# Sumter City-County Planning Commission

## SD-24-04, Mara Hills Subdivision - (County)

**Request:** A request for preliminary subdivision approval to develop a 30-lot single-family residential subdivision

The following review is based upon the preliminary plan submission titled, “*Mara Hills Residential Subdivision*” (*Sheets C1 – C5*), prepared by Jones and VanPatten, LLC and dated January 8, 2025.

**Figure 1 - Site Plan Layout**

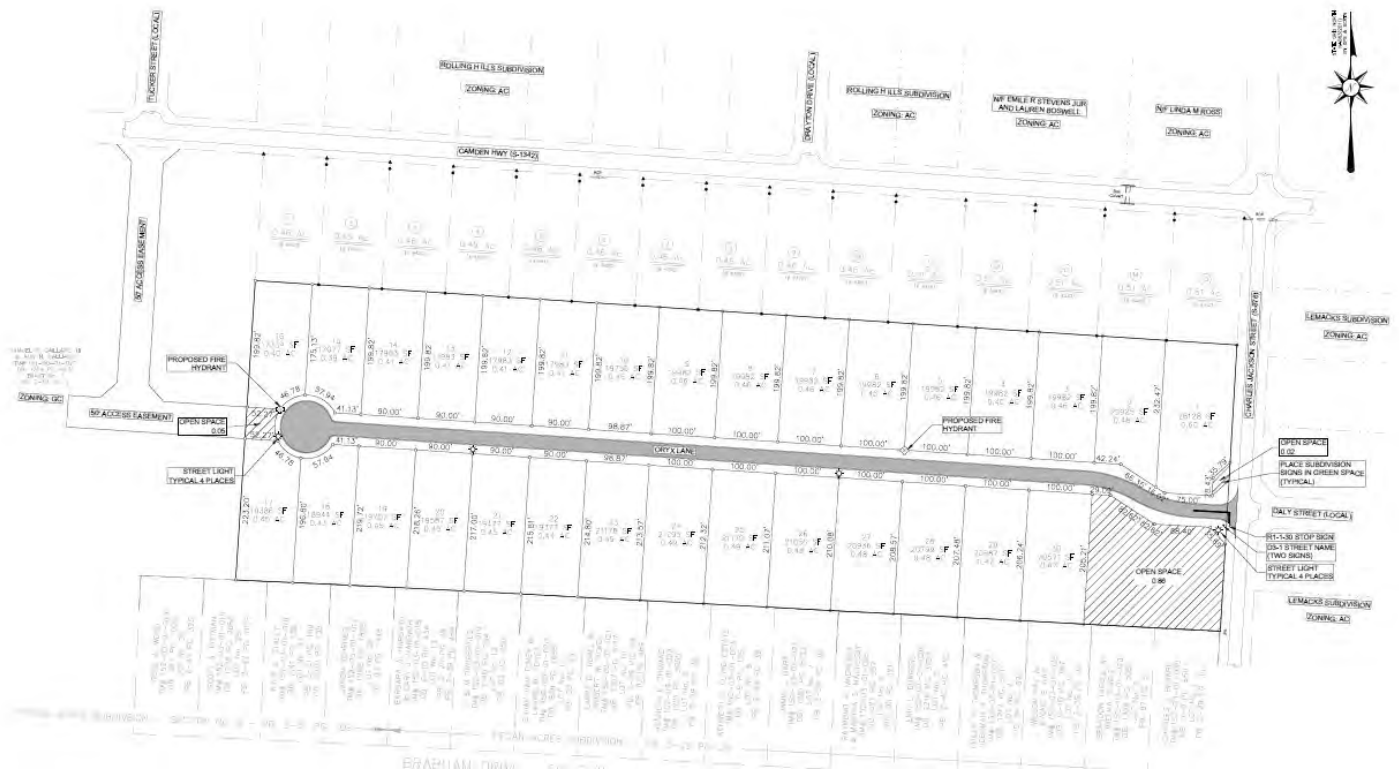
The proposed preliminary plan indicates that proposed single family detached lots range from 16,988 sq. ft. to 26,136 sq. ft. in size, with most lots being approximately 0.45 acres. The lot width for each proposed single-family detached lot as shown on the plan is 100 ft.

The proposed Oryx Lane is considered “local low intensity” per the street standards outlined *Article 8* of the Ordinance. The street will not have on-street parking, will have a 20 ft. pavement width, and 50 ft. total right-of-way (ROW) area. No sidewalks are required or proposed. The street plans meet the minimum requirements of the Ordinance. A full engineering review of the street plans will be conducted by Sumter County Public Works prior to approval to proceed with construction.

**Figure 2 – Proposed Street Buffer Preservation**

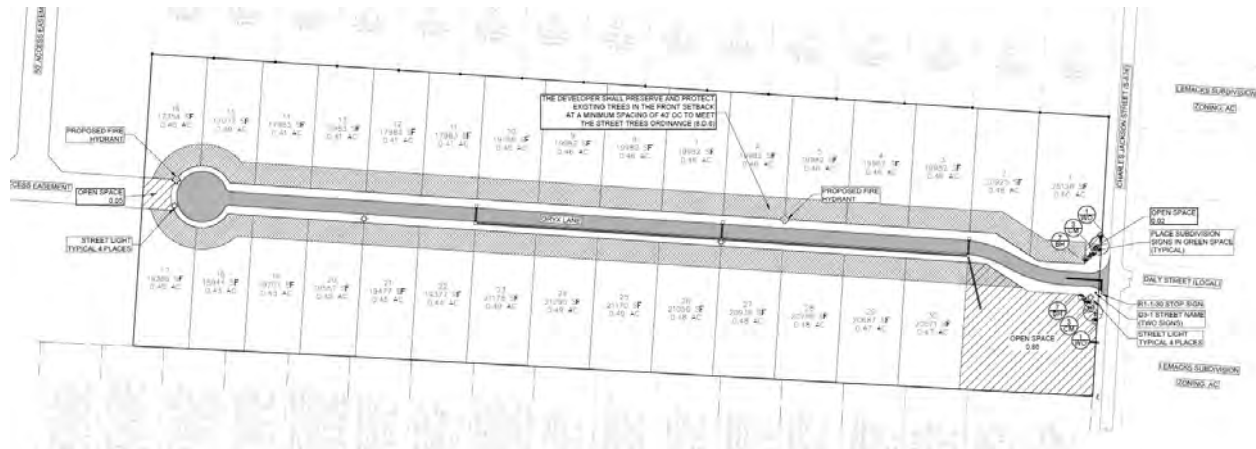
The existing site is wooded via natural growth. No tree survey details have been submitted to date, and the site contains an unknown number of significant/historic trees.

A proposed landscaping plan has been articulated on the submitted plans. The applicant is proposing to preserve and protect existing trees in the front setback at a minimum spacing of 40 ft on center to meet the Ordinance’s street tree requirement. At the subdivision’s entrance, the developer is proposing to plant 2 *Willow Oak* canopy trees, as well as 6 *Natchez Crepe Myrtle* understory trees and 14 *Dwarf Burford Holly* shrubs.

- b. *Street Trees/Front Yard* – Preservation of existing trees in each front yard must be maintained prior to certificate of occupancy approval for each respective lot.

**1** LANDSCAPING PLAN  
SCALE: 1" = 100' - 0"

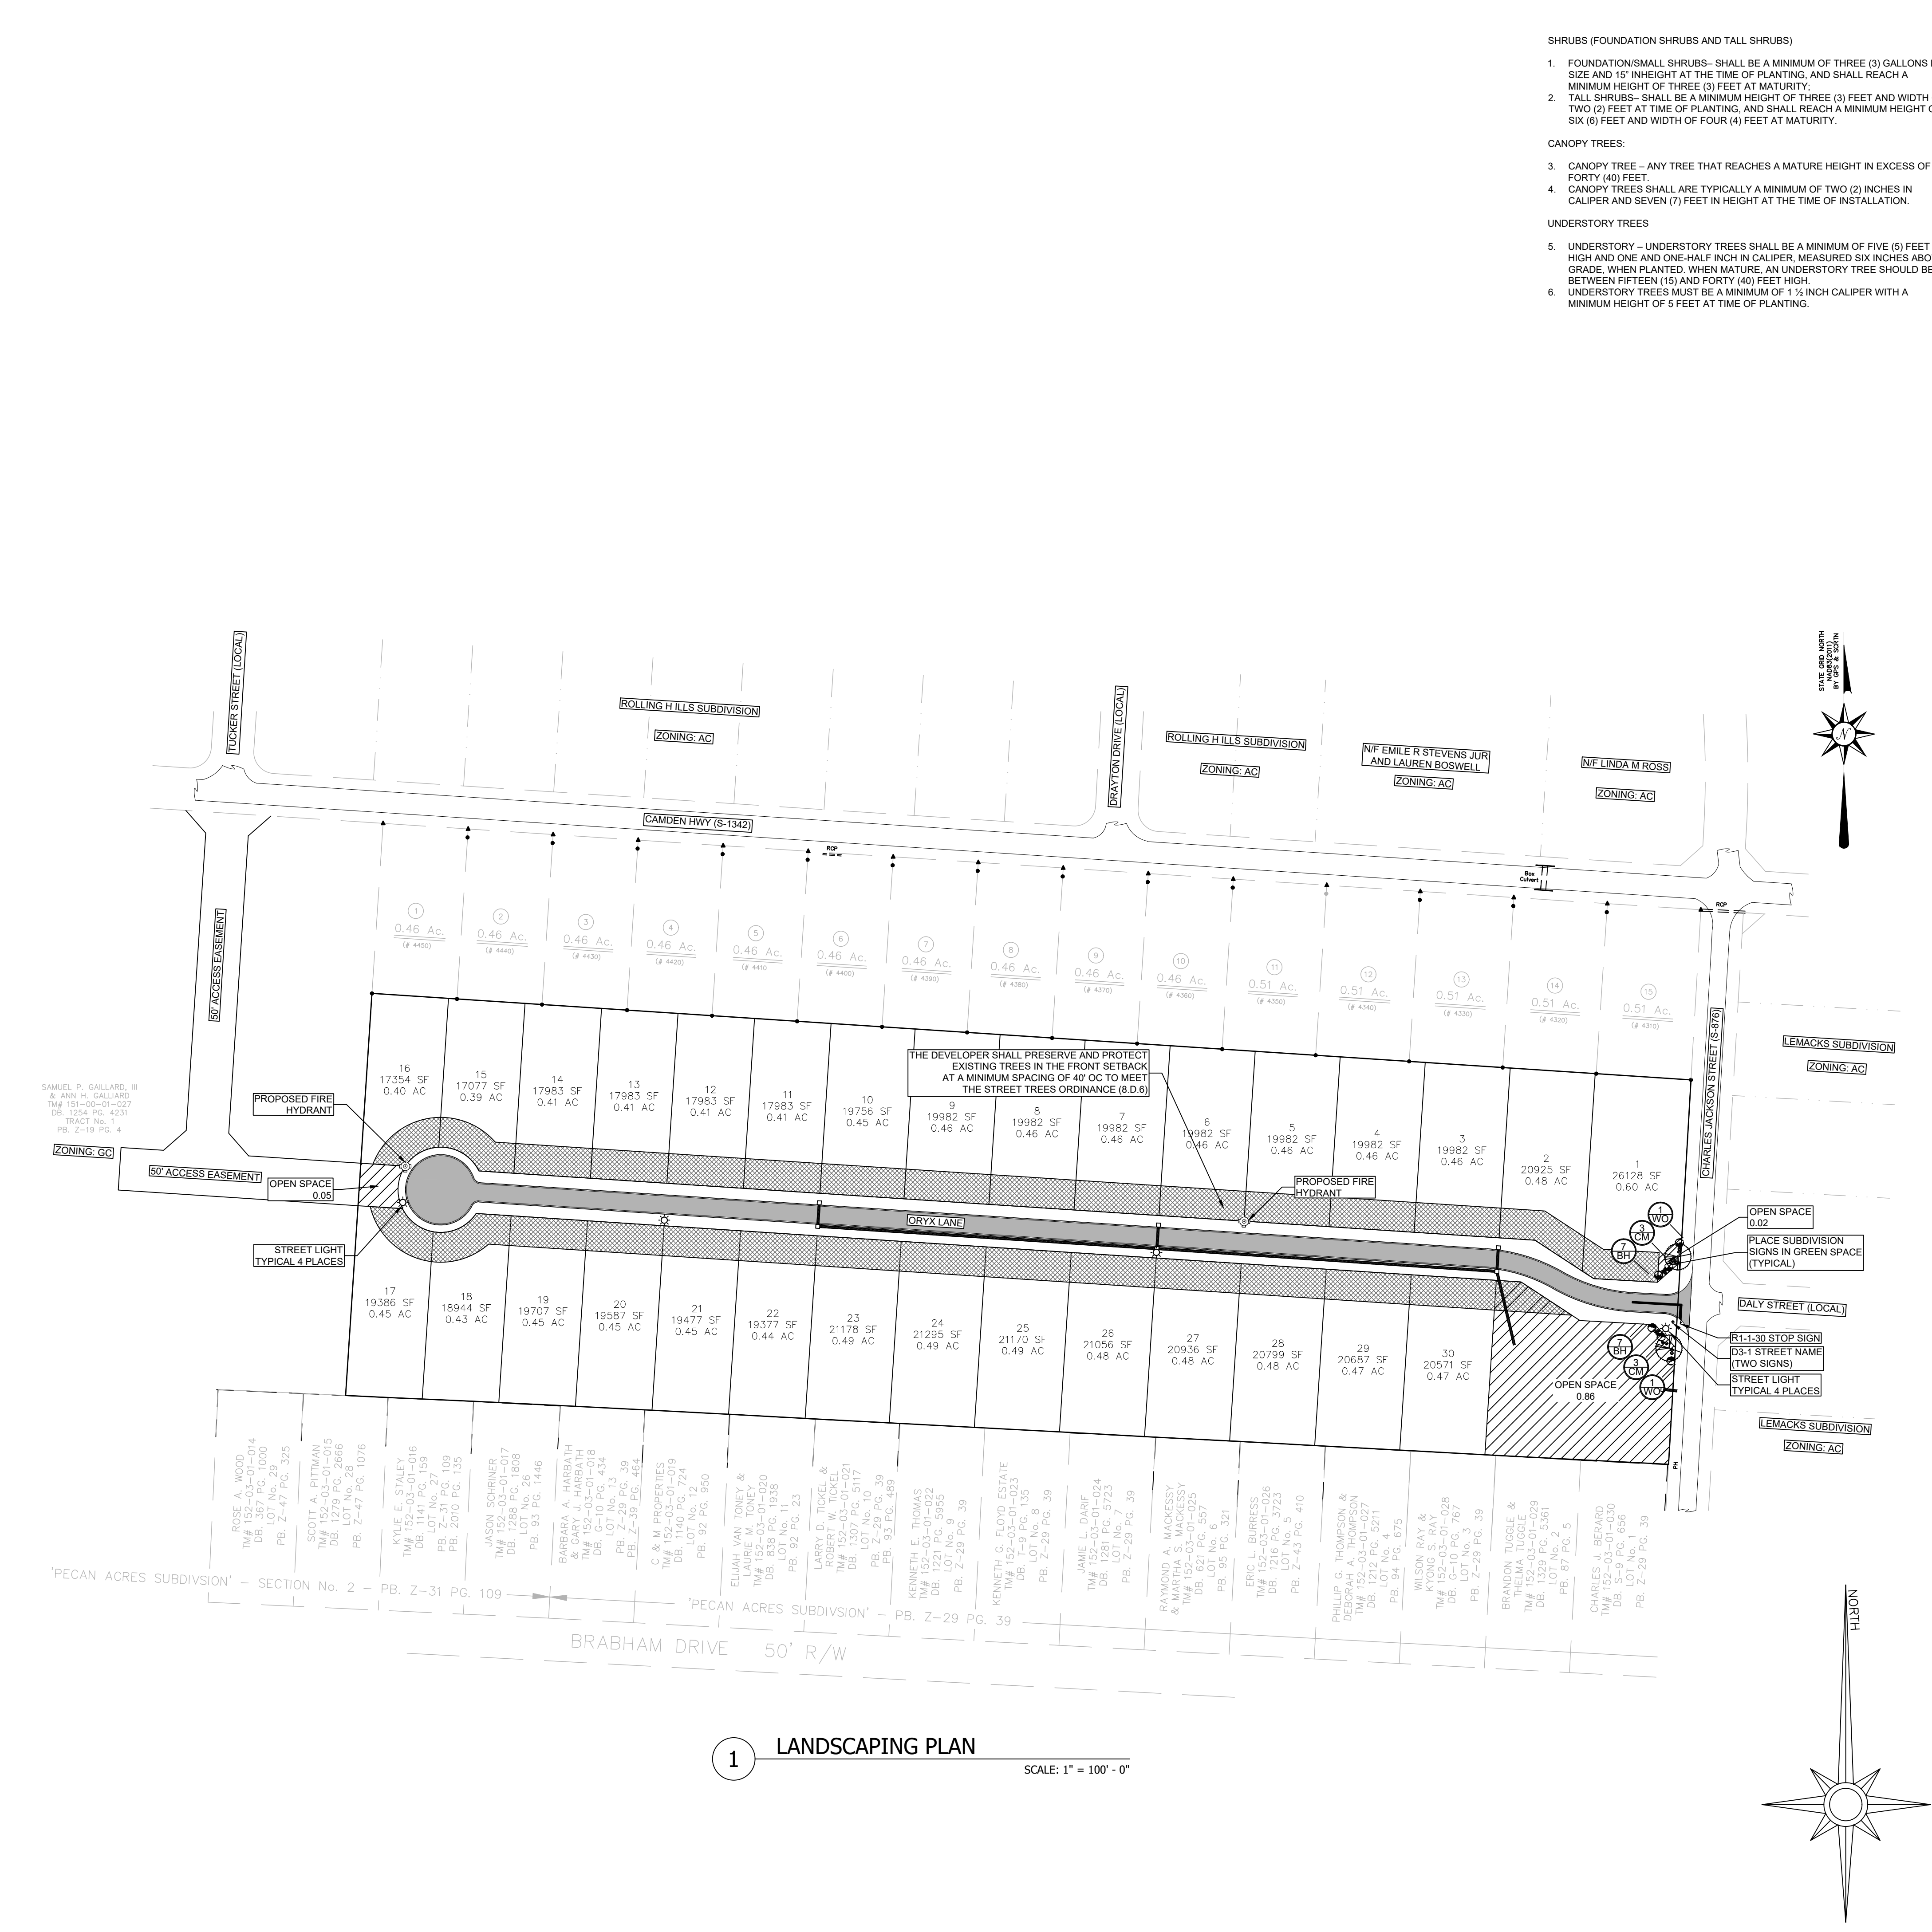
5. Applicant must provide results of tree survey verifying presence or absence of any trees classified as ‘significant’ (10-29” DbH) or ‘historic’ (>30” DbH) per *Article 8 of the Sumter County Zoning & Development Standards Ordinance*.

- b. Stormwater permit and NPDES approval from the Sumter County Stormwater Utility.
  - c. Results of tree survey verifying presence or absence of any trees classified as ‘significant’ (10-29” DbH) or ‘historic’ (>30” DbH) per *Article 8* of the *Sumter County Zoning & Development Standards Ordinance*.

**1** SUBDIVISION SITE PLAN  
 SCALE: 1" = 100' - 0"

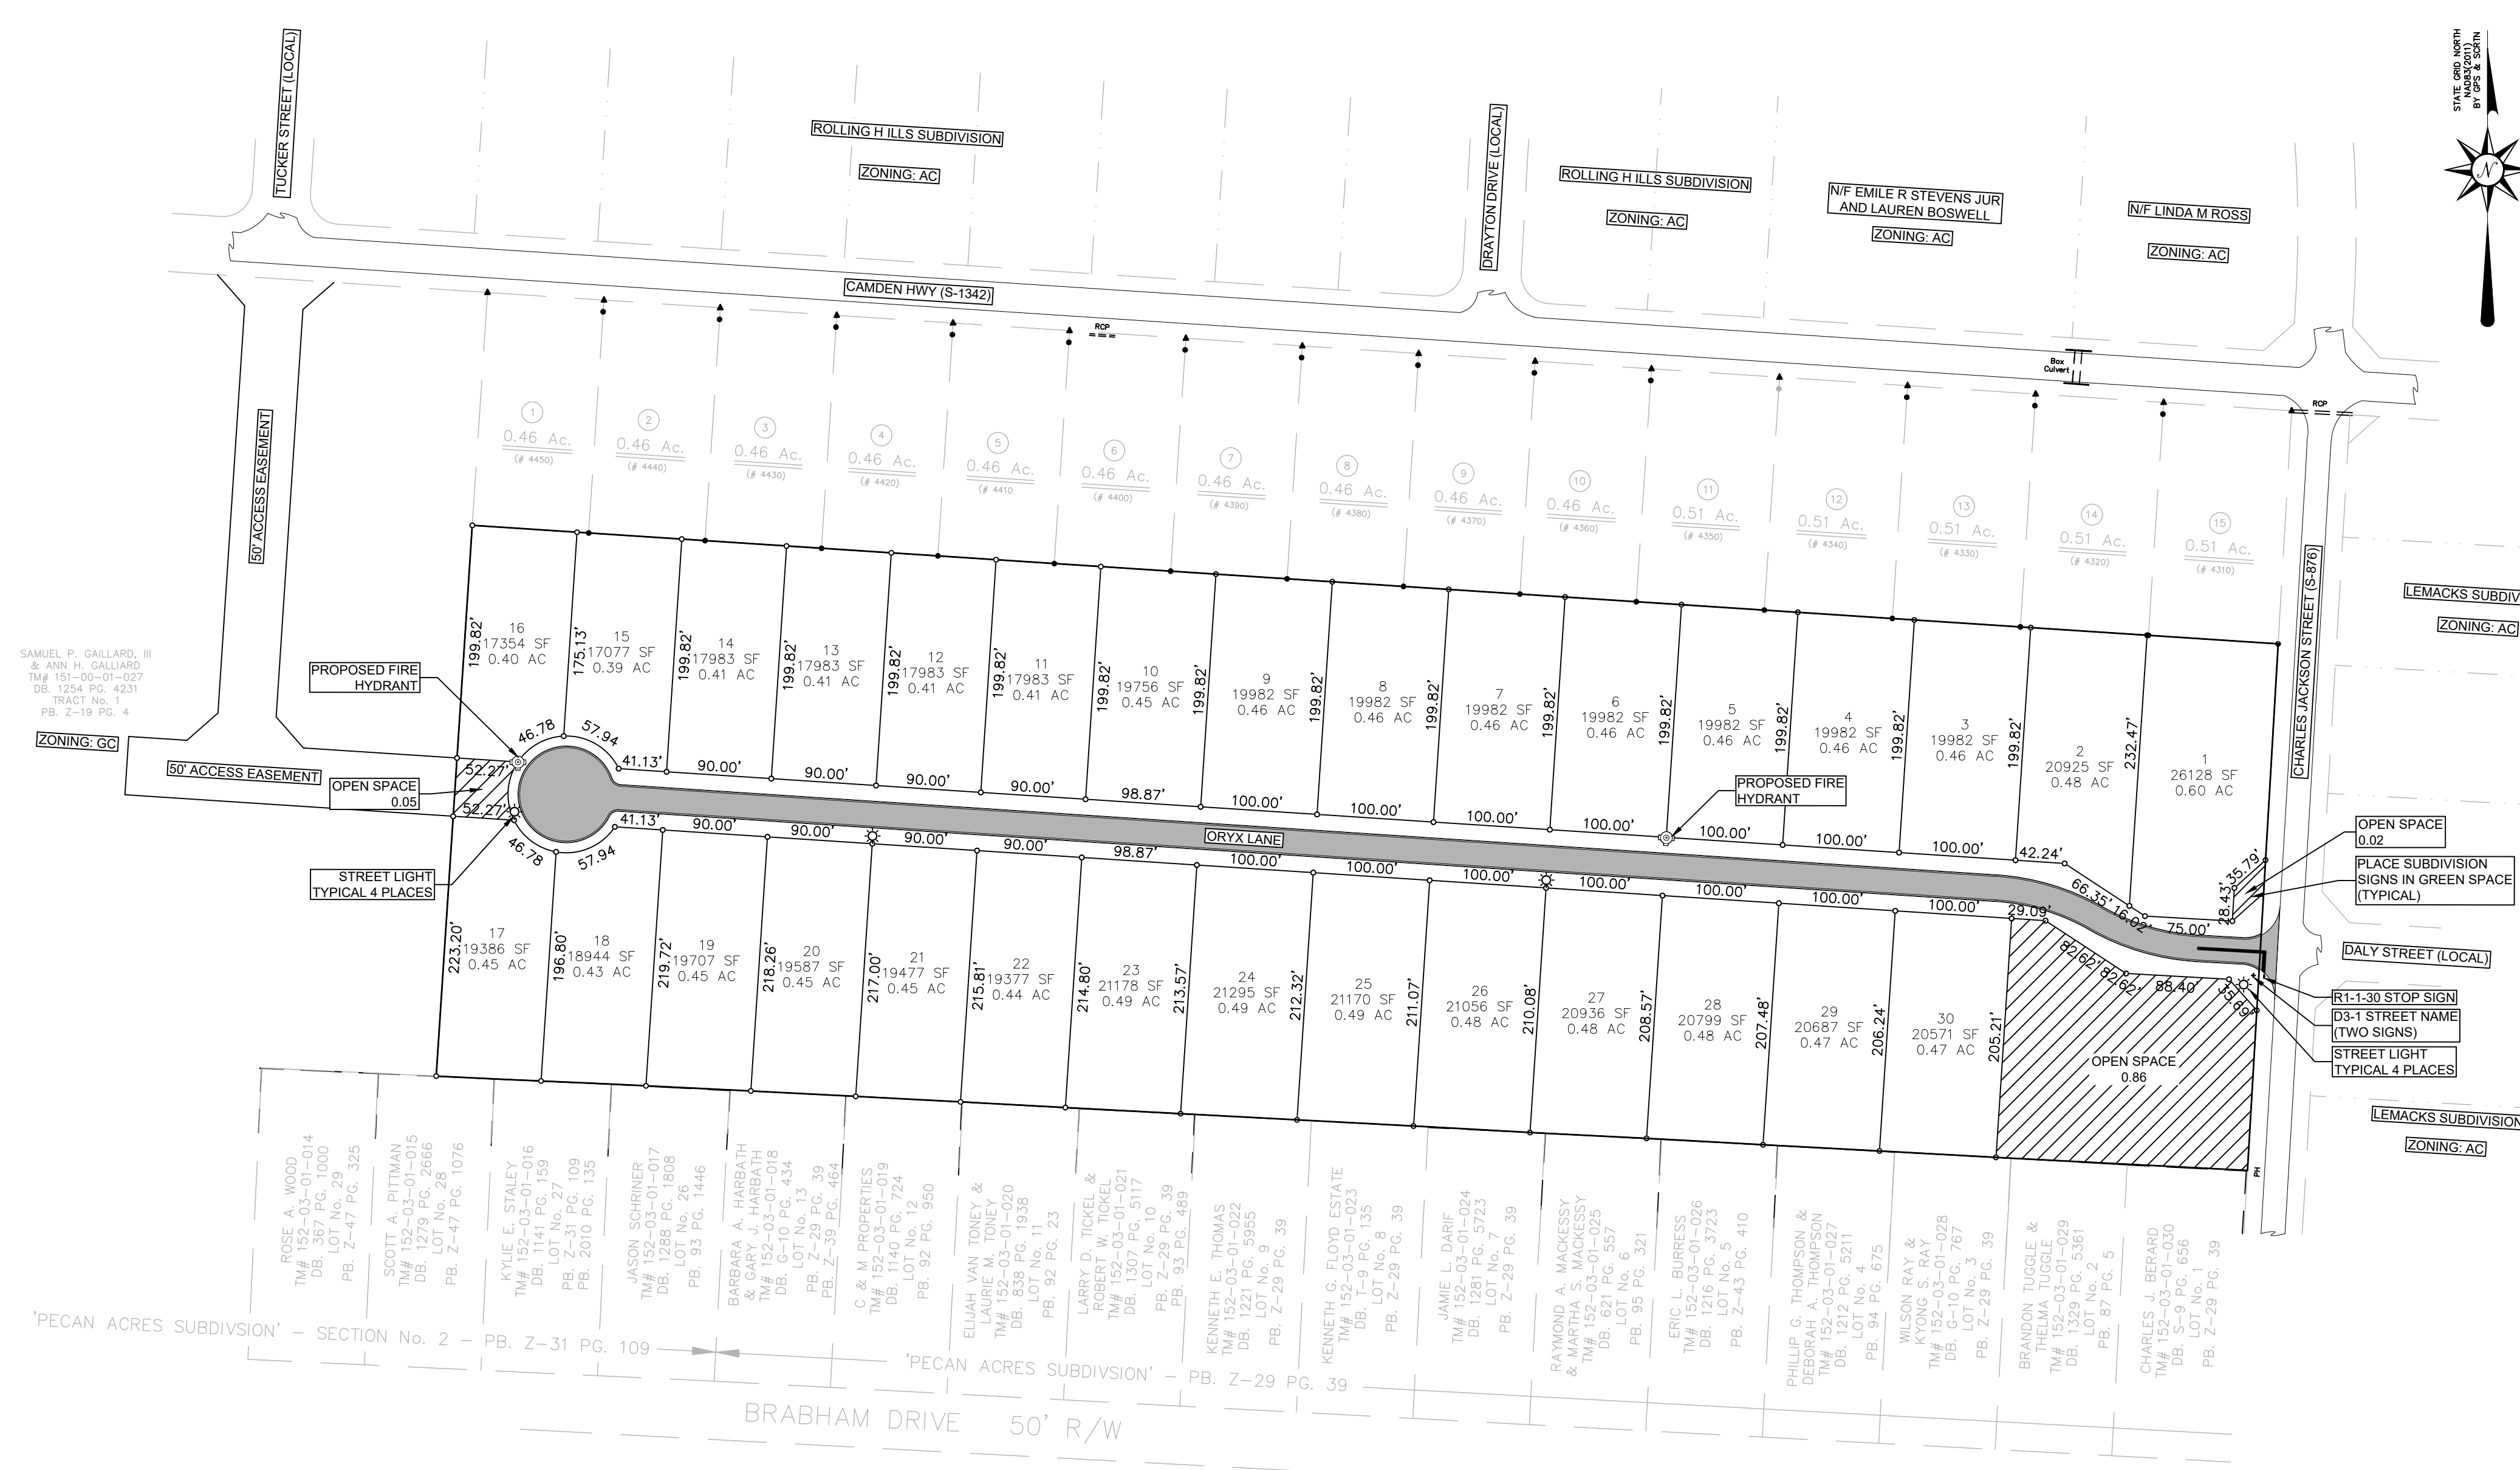
1. Applicant must provide subdivision entrance monument signage details (location(s), type of sign, etc.)
2. Applicant must provide a copy of all known restrictive covenants that apply to the subject property.

3. Applicant must provide confirmation from USPS that community mailbox cluster(s) are not required. If community mailbox cluster(s) are required, applicant must provide updated plan showing location and landscaping for community mailbox cluster(s).

4. Applicant must provide confirmation of entity providing public water service, as site is across the service areas of 2 separate providers (High Hills Rural Water Company and Dalzell Water District).
